Subject: Duke Energy Carolinas, LLC.  
William States Lee III Nuclear Station - Docket Nos. 52-018 and 52-019  
AP1000 Combined License Application for the  
William States Lee III Nuclear Station Units 1 and 2  
Response to Request for Additional Information  
(RAI No. 1244)  
Ltr# WLG2009.03-02

Reference: Letter from Brian Hughes (NRC) to Peter Hastings (Duke Energy),  
*Request for Additional Information Letter No. 055 Related To SRP  
02.05.02 for the William States Lee III Units 1 And 2 Combined License  
Application, dated December 3, 2008*

**Lee Nuclear Station Response to Request for Additional Information (RAI)**

**Figure 1. Effects of Fourier Amplitude Spectrum Integration Range  
at High-Frequency**

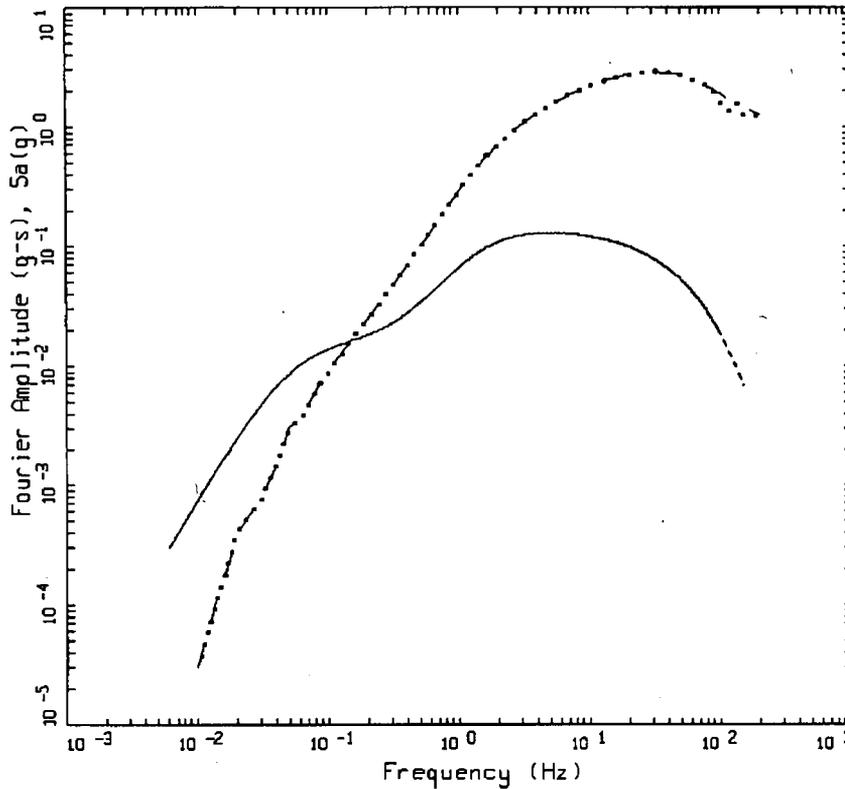
As a result, the confident frequency response of strong motion data in current databases varies from 0.2 to 25 Hz (typical for film instruments) to 0.1 to 100 Hz (typical for digital instruments). The frequency band used by the applicant is much beyond those limits: 0.007 to 150 Hz.

Please clarify what procedures are used to extend the frequency band to such values. How are you confident that results from frequencies 0.007 to 150 Hz (well beyond the confidence level of strong-motion recordings) are reliable and not contaminated by noise? If your response is based on theoretical results, please provide information on constrains at both low and high frequency ends of the spectrum, and validation of your model at both low- and high-frequency ends beyond the empirical data.

It is certainly true that the majority of strong motion data contain reliable information on Fourier amplitude spectra (FAS) over a restricted frequency range of about 0.1 hertz (Hz) to about 50 Hz for digital data and about 0.2 Hz to about 25 Hz for film records, all depending on magnitude, distance, and, to some extent, site conditions. For high frequencies Boore (1983, Reference 1) has demonstrated that the point-source model works well for magnitudes (M) down to M 0.4 with Fourier amplitude frequencies up to about 400 Hz. For typical strong motion data, the contribution to response spectra at peak acceleration (e.g., 100 Hz) from FAS beyond about 25 Hz to 50 Hz in Western North America (WNA) and about 50 Hz to 70 Hz at hard rock sites in Central Eastern North America (CENA) is small.

To compute control motions, low-pass filters at 50 Hz in WNA and about 60 Hz in CENA were applied and reflect our typical corner frequencies for the Butterworth filters. The filter for CENA simulations is simply to force saturation to peak acceleration at 100 Hz for convenience (convention). The extension of the integration to 150 Hz is done for cases with kappa ( $\kappa$ ) less than 0.006 sec and without low-pass filters. As an extreme case to illustrate the contribution to high-frequency response spectra by the FAS at high-frequency, Figure 1 (Attachment 1) shows results computed for M 7.0 at a Joyner-Boore (JB) distance of 1 km for CENA hard rock conditions (Reference 2.5.2-287). For the nominal FAS integration to 150 Hz, the corresponding response spectrum (5% damped pseudo absolute acceleration) peaks near 30 Hz and saturates monotonically to peak acceleration near 150 Hz (no filters applied). Restricting the FAS integration to 100 Hz shows an impact in the response spectrum beginning near 90 Hz and quickly saturating to peak acceleration just beyond 100 Hz. While Boore (1983, Reference 1) has shown the point-source model works well beyond 100 Hz, high-frequency response spectra (beyond the peak) are controlled by lower frequencies in the FAS. This sensitivity to lower-frequency and saturation to peak acceleration is a consequence of the width of the oscillator transfer function increasing directly with oscillator frequency. At high-frequency, where the FAS is depleted, the oscillators incorporate lower-frequency energy where the FAS has a broad peak, finally saturating to peak acceleration as the oscillator transfer function increases width with increasing oscillator frequency. As a result, validations of response spectra for frequencies up to and including peak acceleration, the highest frequency of interest for engineering design, indirectly validates the FAS to slightly higher frequencies, beyond which integration has no effect.

**Figure 1 (Sheet 1 of 2). Median Estimates of Amplification Factors (5% Damped Response Spectra) Computed for M 6.0 and a Deep Firm Soil Site in the CENA Using the EPRI [1993 (FSAR Reference 2.5.2-273)] Modulus Reduction and Hysteretic Damping Curves**

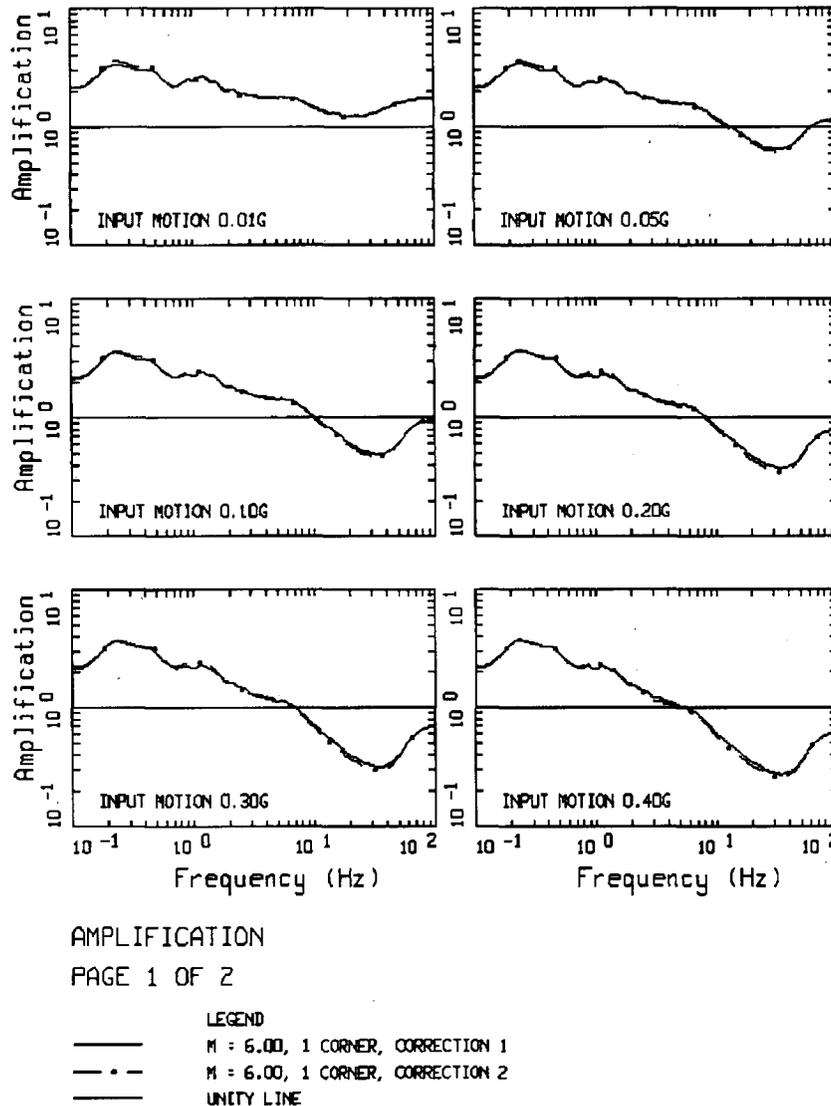
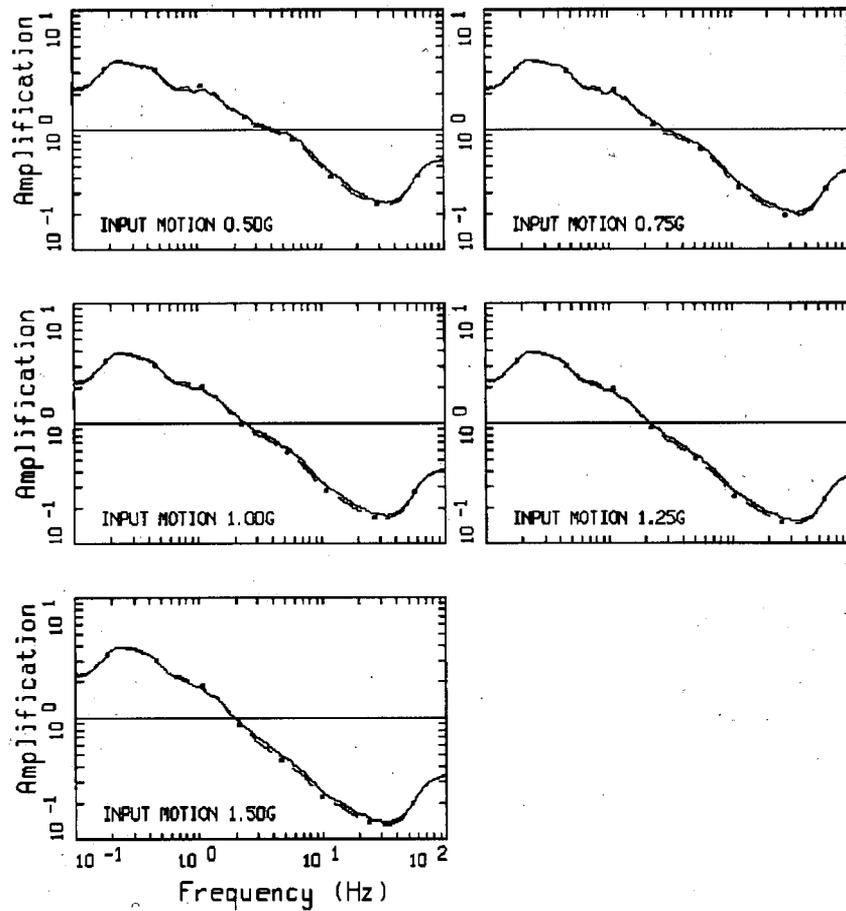
Paragraph 1 of Section 2.1.2 of the Enclosure 1 report states that for application to transfer functions differences in response spectra due to different corrections at low-frequency are cancelled through taking ratios.

Please clarify why corrections to the duration of the time series (time domain) can be cancelled by taking ratios (frequency domain). Please clarify if response (not Fourier) spectral ratios are used.

Please refer to Table 1 and Figures 1, 2 and 3, attached. To demonstrate the effects of alternate correction factors on computed transfer functions, Figure 1 compares amplification factors computed for  $M$  6.0 (Table 1) and a deep firm soil site in Central Eastern North America (CENA) (Figure 7, Reference 1) using both the Vanmarcke (1976) (Reference 2) approach (correction 1) and that of Boore and Joyner (1984) (Reference 3). Over the entire frequency range (0.1 hertz (Hz) to 100.0 Hz), as Figure 1 illustrates, there is little difference in the amplification factors computed using the two correction factors. In general the differences are less than about 5% and occur principally at high-frequency, beyond about 2 Hz. With a total duration of about 3 seconds (0.33 Hz) for 1.50g (Table 1), the corrections have the largest impact at low-frequency (below 0.33 Hz), where the difference is quite small.
